A	B	C	D	E	F	G	H	I	J	K	L	M	N	O	P	Q	R	S	T	U	V	W	X	Y	Z	AA	AB	AC	AD	AE	AF	AG	AH	AI	AJ	AK	AL	AM	AN	AO	AP	AQ	AR	AS	AT	AU	AV
1	DEV NUMBER:				ORIGINATOR:										DATE:				<b>RAIN BIRD</b>										BUSINESS UNIT (SBU) W/ PRIMARY DESIGN CONTROL:										SHEET:									
2	DEV25-0003				Abdul I. Castillo										10-Jan-25														>>> GLF										1 OF 1									
3	DMR# (IF APPLICABLE):				DEVIATION NEW <input checked="" type="checkbox"/>										<b>DEVIATION FORM (DRAWING)</b>										AFFECTED MFG PLANTS (WHERE USED):																							
4					TYPE: EXTENSION <input type="checkbox"/> OF DEV#:																														FORM#233813-01 REV:N													
5	TOP-LEVEL SKU P/N(S) AND MODEL NUMBER(S):														EFFECTIVITY DATE:				EXPIRATION DATE:				005 LAM <input type="checkbox"/>		013S STL <input type="checkbox"/>		025 OTY <input checked="" type="checkbox"/>		041 NOG <input type="checkbox"/>

16	3.- Built up 16 weeks of inventory. Oscar Santillán.																																															
17	4.- Validation will be required. A. Castillo																																															
17	Design intent		DRAWING REVISION:				DEVIATION REVISION:				DRAWING TITLE/ PART DESCRIPTI

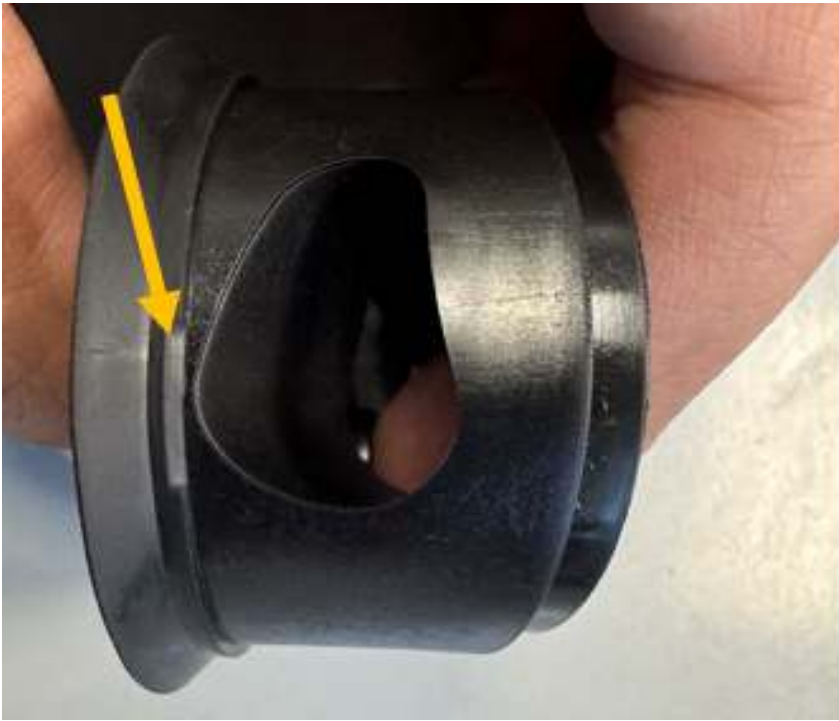
9	213784 Housing nozzles Comolded 552. The cavity blocks were shattered in an attempt to weld and recut them. The steel was so thin in one place that it cracked multiple times. The second shot (rubber) could pass through the crack. As an alternative, cavity blocks were soldered, modifying the surface as seen in the photo.																																															
10																																																
11																																																
12	RISK ASSESSMENT/ CORRECTIVE ACTION PLAN (NAMES & DATES)/ COMMITMENT:																																															
13	Low risk																																															
14	1.-Part has no FFF concerns, only cosmetic, as confirmed by Altan T. and Javier G.																																															
15	2. Repair the affected inserts. Jorge Rivero is the champion of the restoration process. Mold repairs take four weeks.

213784 Housing nozzles Comolded 552, Cavity blocks were cracked. An attempt to weld and recut it. The steel was so thin in this area that it cracked several times. the second shot (rubber) could going to flash through the crack. As an option, cavity blocks were solder-changing the surface as described in the picture.
